# Issues to consider regarding 28 Lawrence St Freshwater Development

## Application (DA 2025/0077)

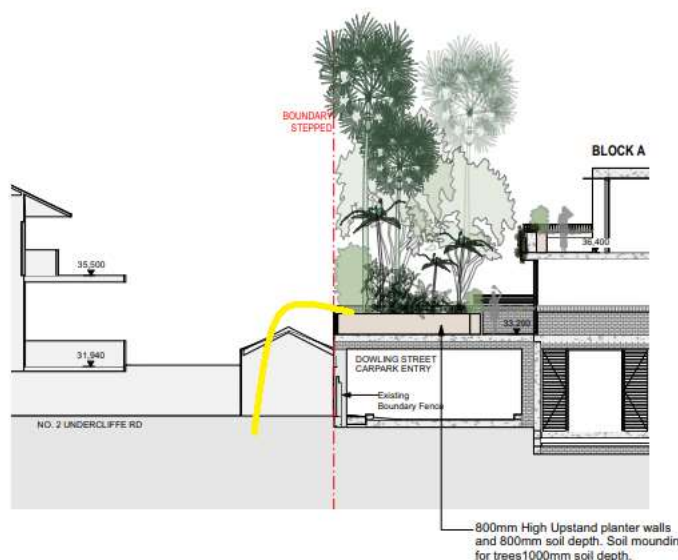
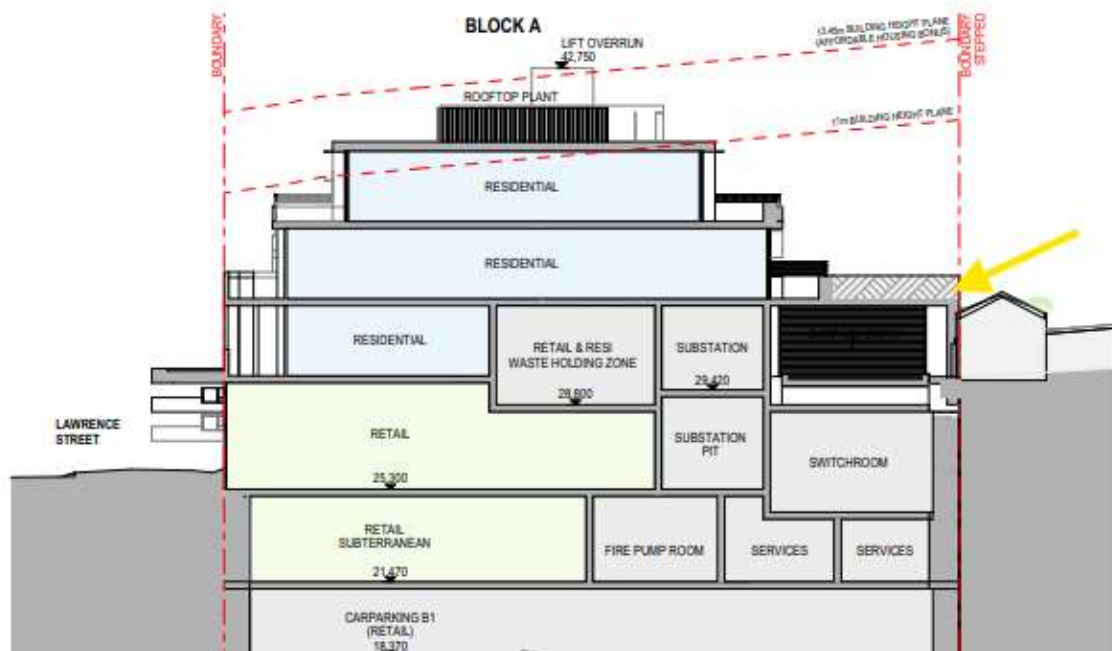
There is not compliance with the set-back requirements where Shops back onto a low Density Residential Zone. The requirement is for at least a 9 metres setback from the boundary of Residential Zone to the development -> in some instances this is only 2.5 metres.

Additionally, there is **no setback** at ground level for the three properties that back onto the entrance of the carport at the western end of the development.

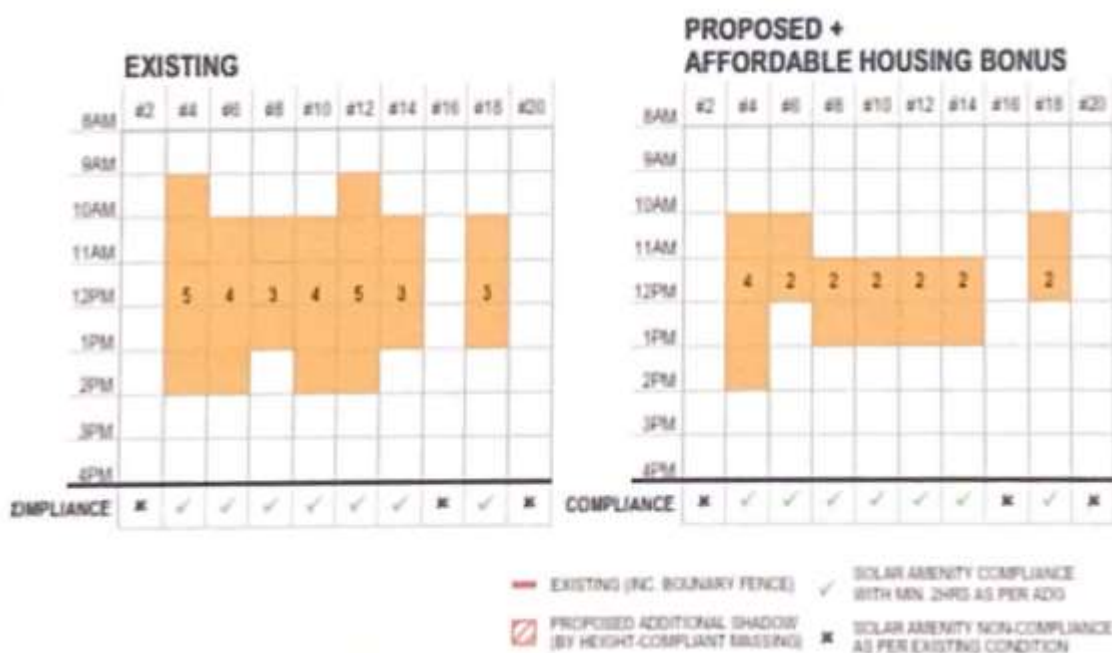
The Development Application does not comply with Clause D6 Access to Sunlight of Warringah DCP (*adjoining dwellings are to receive a minimum of 3 hours of sunlight between 9am and 3pm on June 21*). And needs to be amended to raise the current result of the Plan to be from 2 hours to 3 hours.

Figure 25 Viewpoint 1: 8 Undercliff Road – proposed view

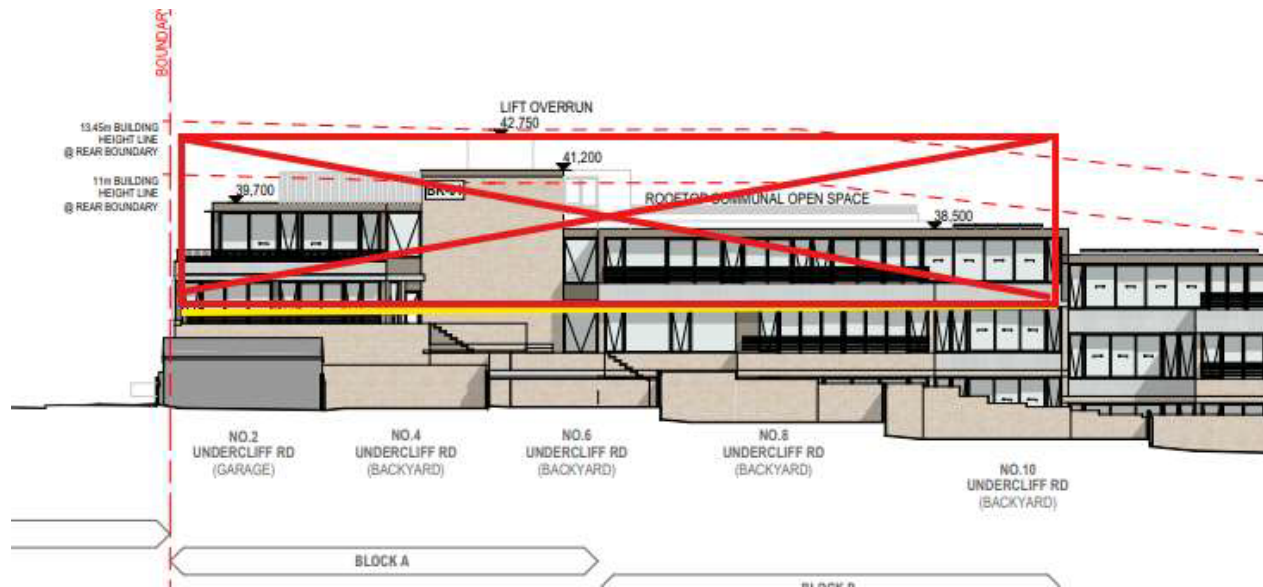
The above screenshot (from page 13 of the Plans – Master Set document), shows the change in the loss of outlook. The yellow line is the current level of the shops in Lawrence Street, from the view at 6 Undercliff Road lounge room, and the Red box shows the level of clear space and clear view lost that changes the distance of outlook from roughly **three kiloMetres to 20 Metres**.

Additionally, the proposed View above does not display the impact of Landscaping as set out on Page 18 of the ‘Landscape Design Report’ which indicates that significant landscaping will change this view. Additionally, the concrete platform behind the brick wall is not located on the page 18 view.
